In support of comment #9

Leon Bruckman (Huawei)

Cl 153 SC 153.2.3.2.4 P 87 L 23 # 9

The OTU4 frame

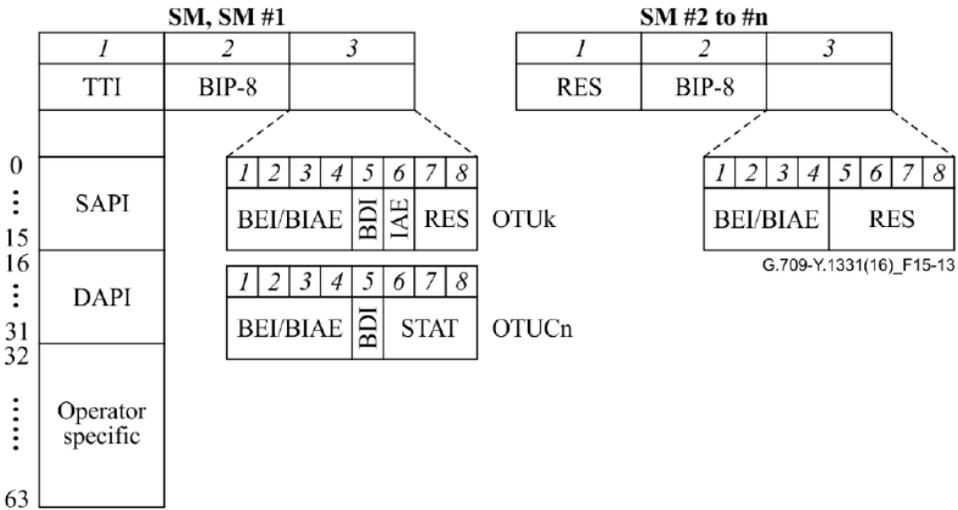
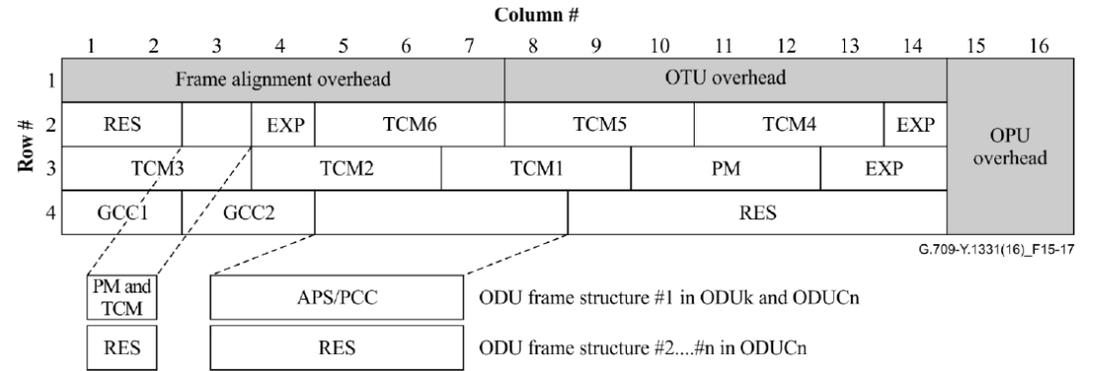
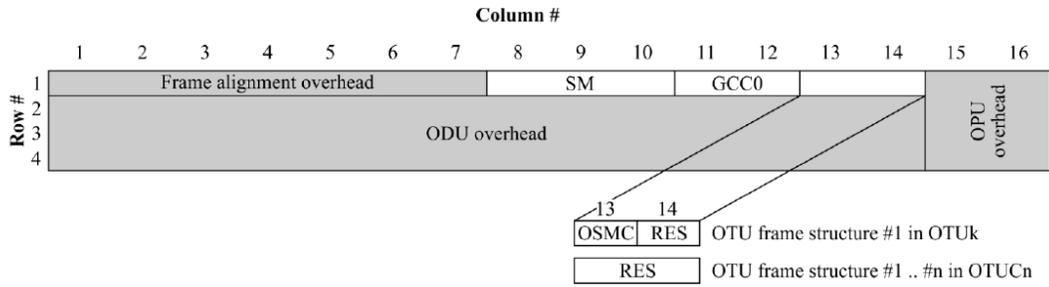
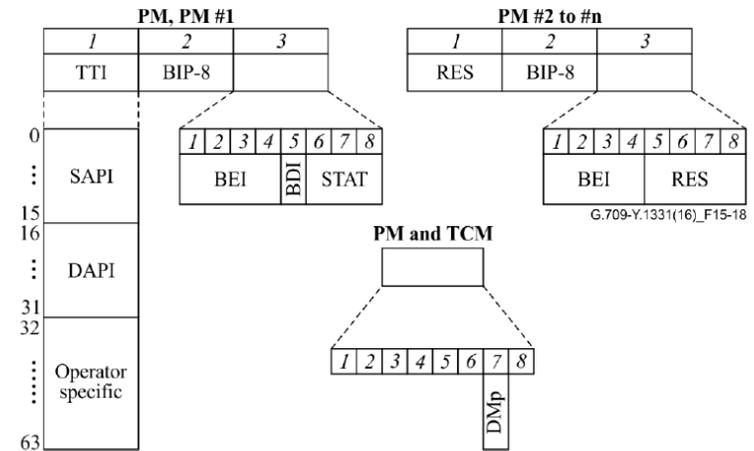
The note may mislead people to think that the 100GBASE-RZ signal is interoperable with an OTU4 interface, but this is not the case since all OAM fields of an OTU4 signal (except FAS, MFAS and PT) are not assigned in a 100GBASE-RZ signal.

- It is agreed that the 400GBASE-ZR signal is not interoperable with OTU4 since most of the OTU4 fields are missing.
- PT is not required for 400GBASE-ZR.
- It is not clear why PT facilitates interconnection with OTN implementations more than any other OTU overhead field.
- Suggestions:
 - Remove the requirement for PT transmission
 - Change the Note to:
 - Interworking with OTU4 is supported if OTU4 and ODU4 overhead is operated as specified in G.709 and G.798

PROPOSED REJECT.
Filling in the FAS, MFAS, and PT are part of the adopted baseline.
The wording is "may facilitate interconnection with", not "will interoperate with". It is fully correct that more is needed (e.g., the far end needs to be able to be provisioned to ignore other overheads not filled in by a 100GBASE-ZR PHY).
